**CERTIFICATE OF APPROPRIATENESS**

**Proposal:** Alteration – Signage

**PROPERTY LOCATION**  
**TEXAS COMPANY BUILDING**

RE: Proposed signage at 1111 Rusk, Texaco Building Renovations

**BLADE SIGN**

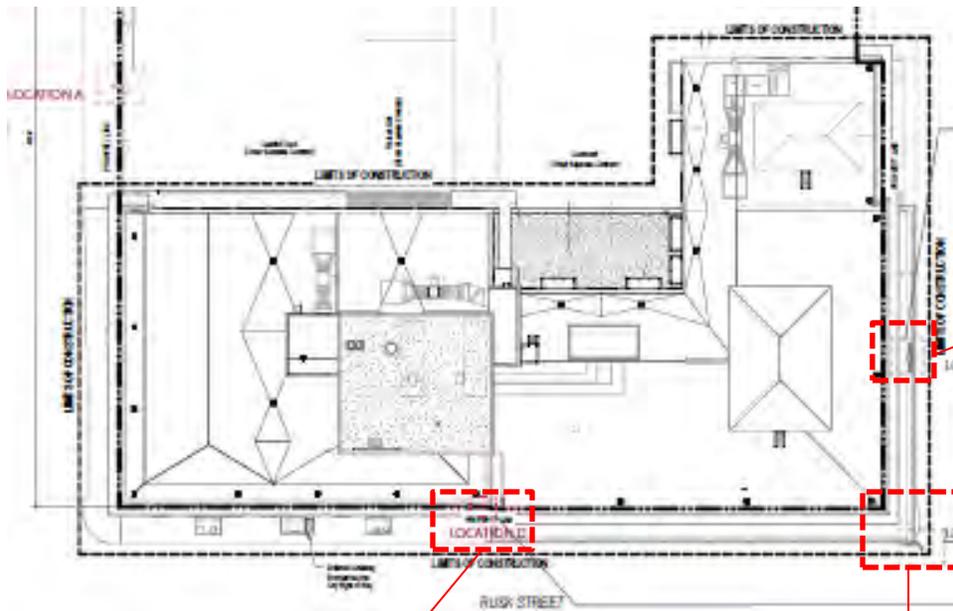
Location C (San Jacinto and Rusk Streets, corner-mounted blade sign): 4'-0" x 20'-0" sign type is acceptable at proposed location, as described in the application narrative and supporting documents.
